Date: September 11th, 2024

Project: All Seasons Arena Renovation	City Project No.: 11075 State Project No.:
Contractor: Met-Con Construction	Date of Contract:

Description: Change Order 006 –

P2-10C

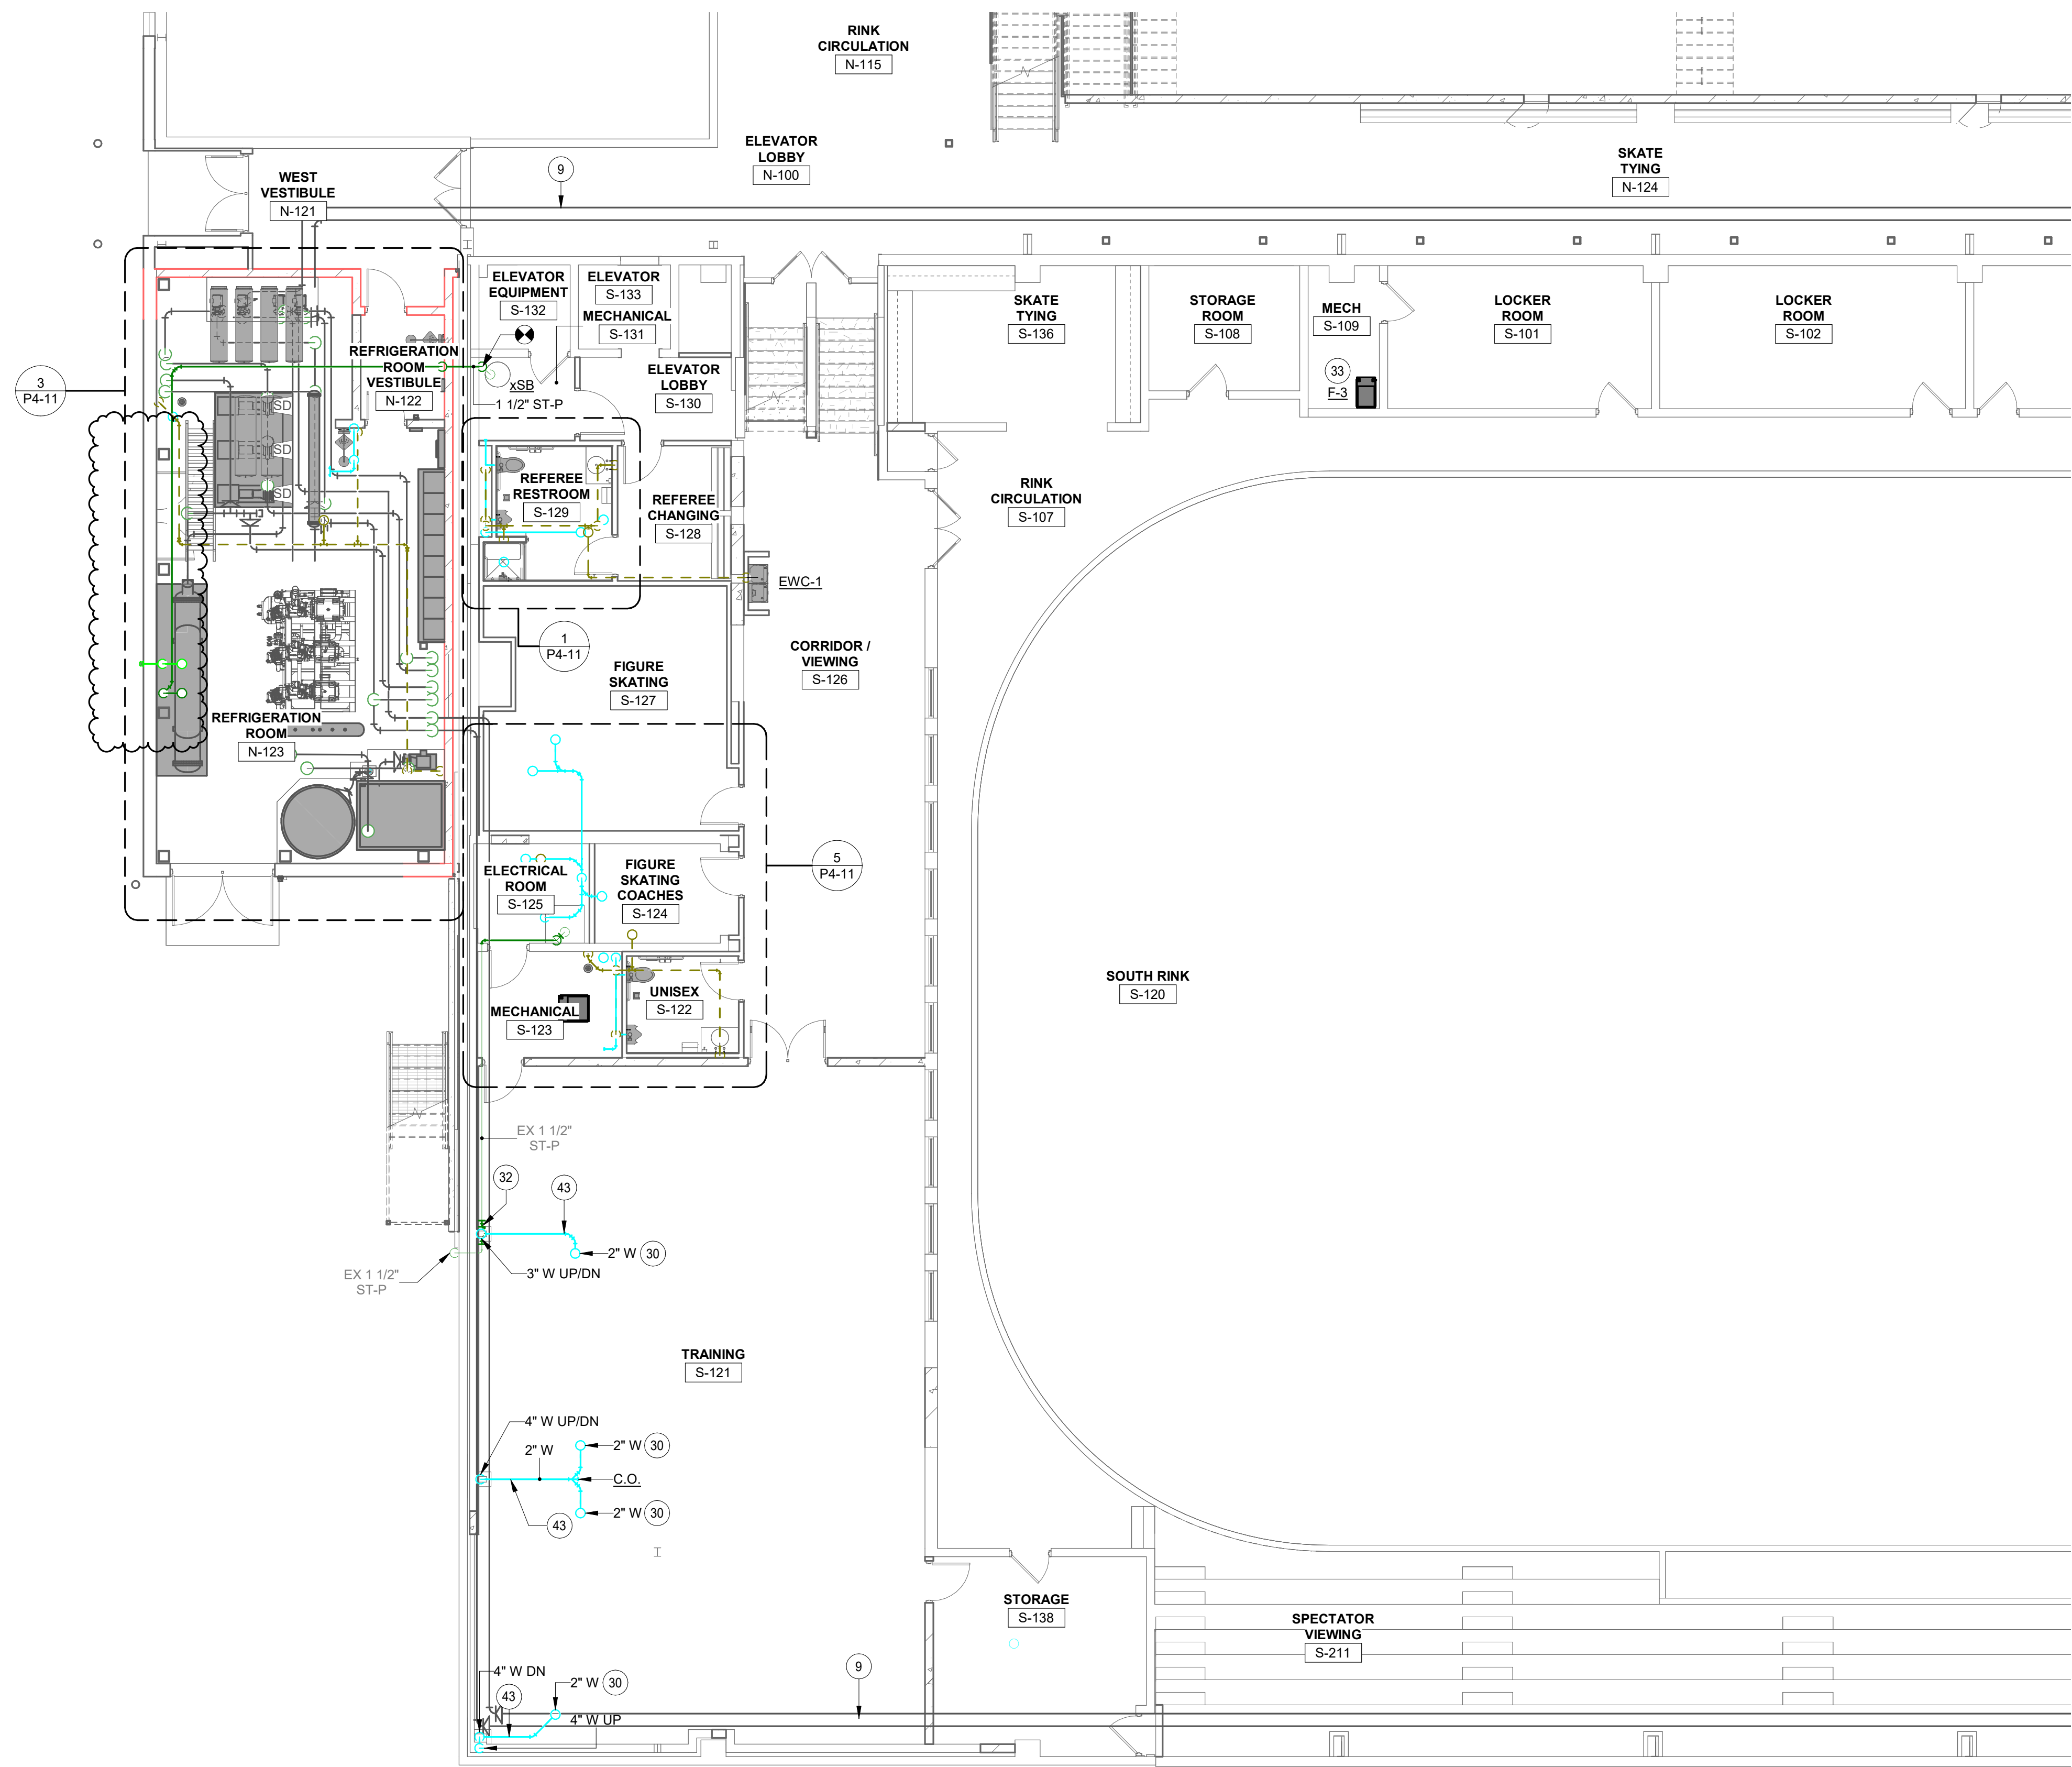
- a. Revised ceilings to be 8'-0" elevation in rooms: S-122, S-124, S-128, S-129, S-130
5. Refer to revised Plan Sheet P2-10C – FOUNDATION PLUMBING PLAN AREA C

- a. Shifted 4" storm primary drain to the south
6. Refer to revised Plan Sheet P2-11C – FIRST FLOOR SANITARY/STORM PLUMBING PLAN AREA C
 - a. View update, storm primary and overflow drain lines shifting to the south

Wall 15' x 8'.6"

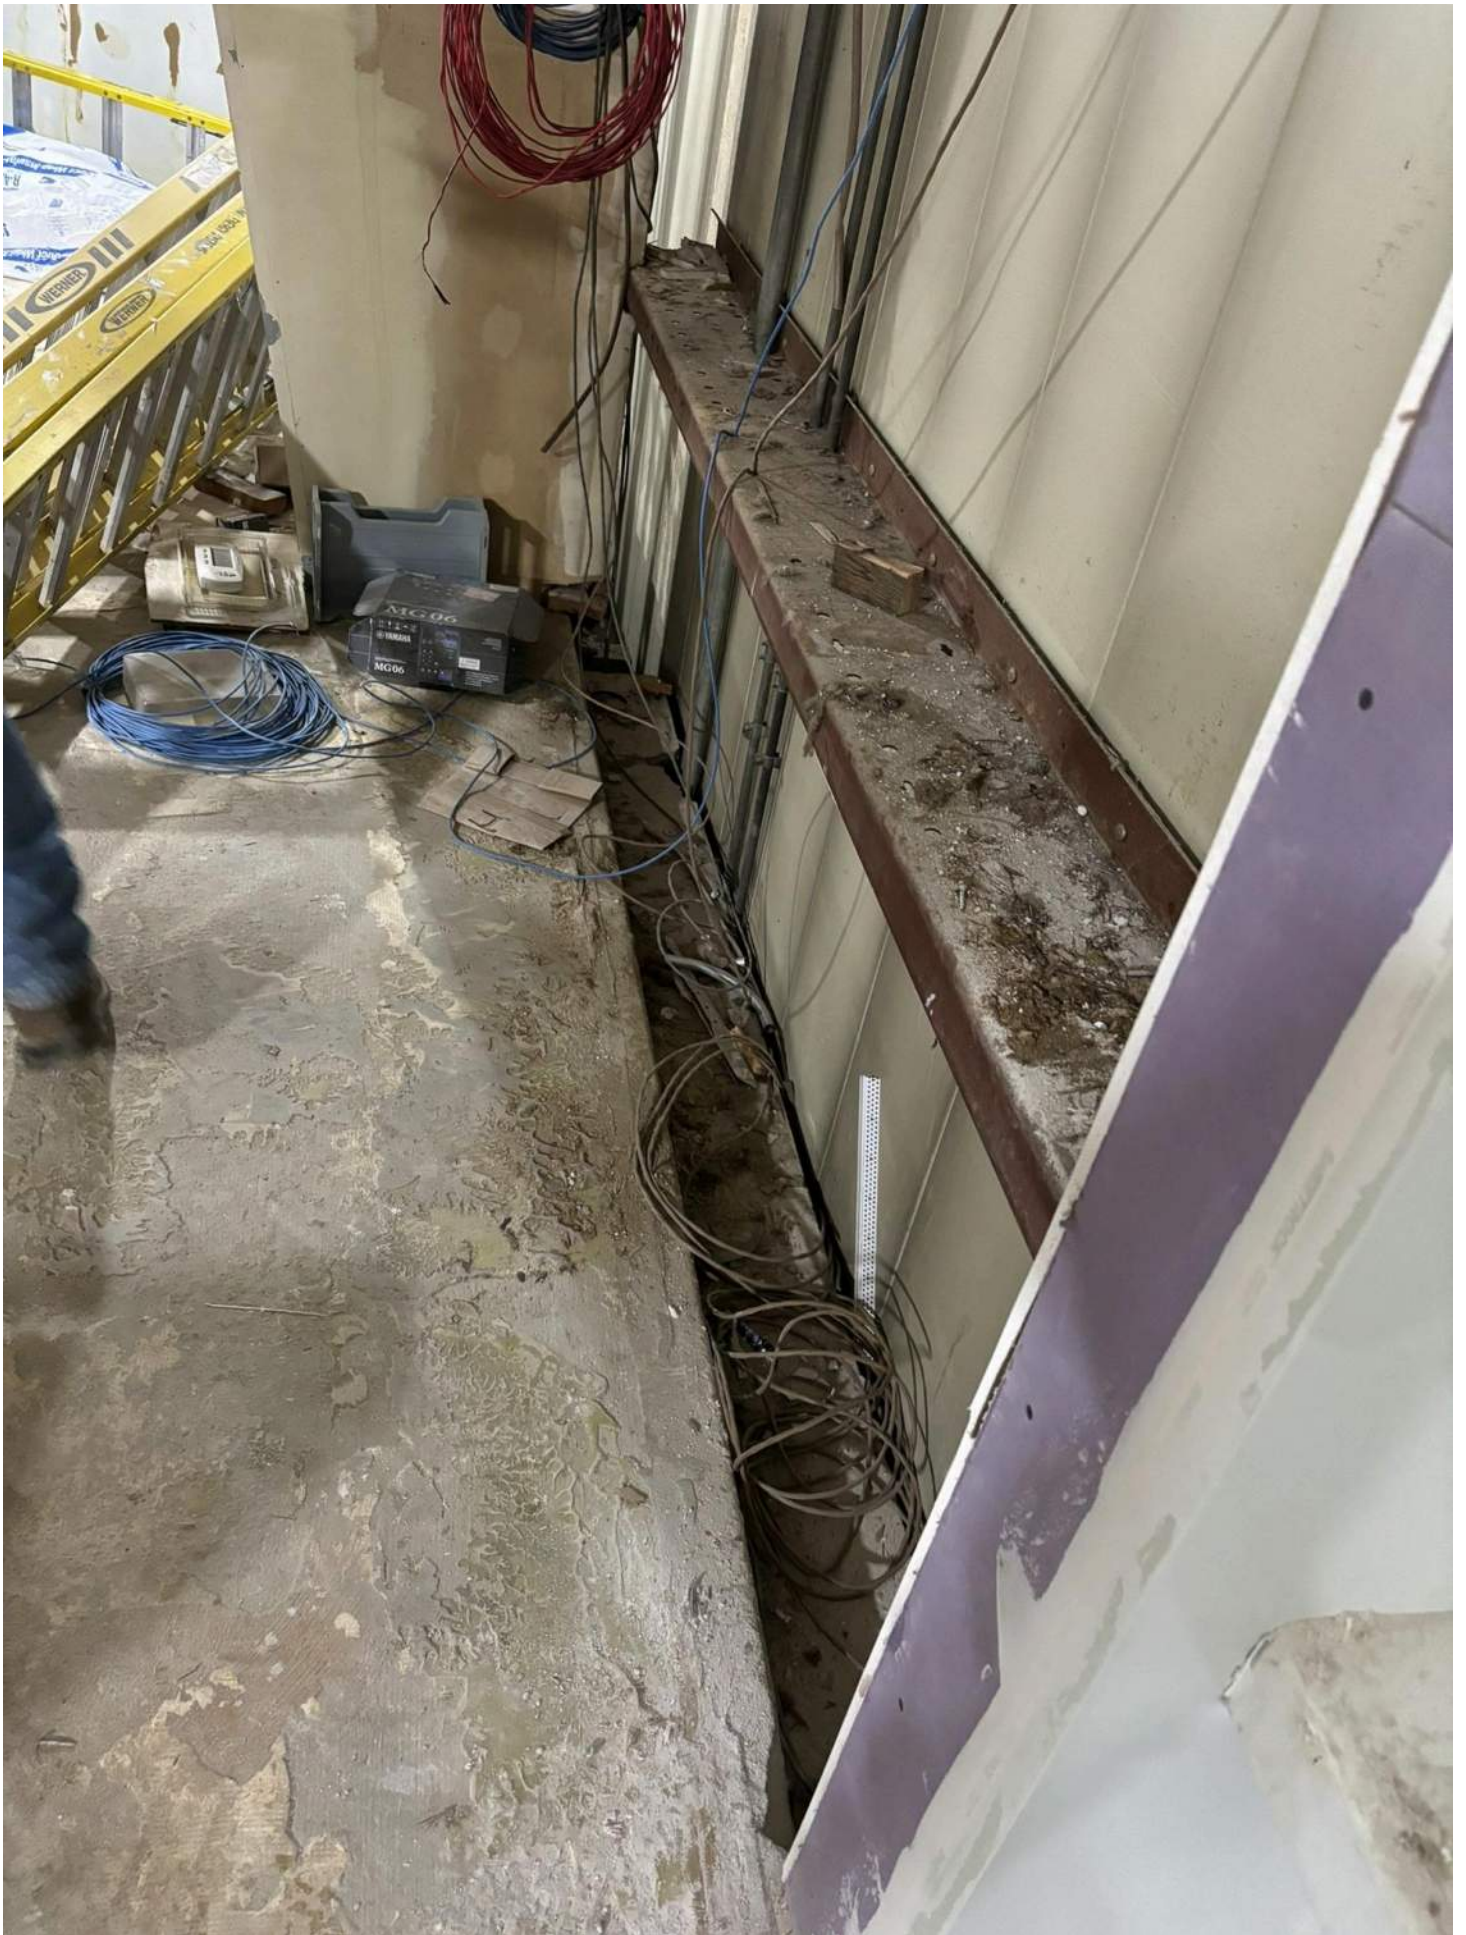
At the owners request, we are proposing to ADD a new metal stud wall, complete with drywall and paint, in the hallway between Press S-201 and Circulation/Viewing S-212 to cover the existing metal building structure, conduits, and fill in the existing gap at the end of the precast plank (see attached images.)

Description of Change: Build a 8' 6" long wall roughly 14' tall to cover existing girder/MEPs.

Add \$325.00 for painting the 15' x 8'.6" wall.
Labor \$225.00
Materials \$100.00
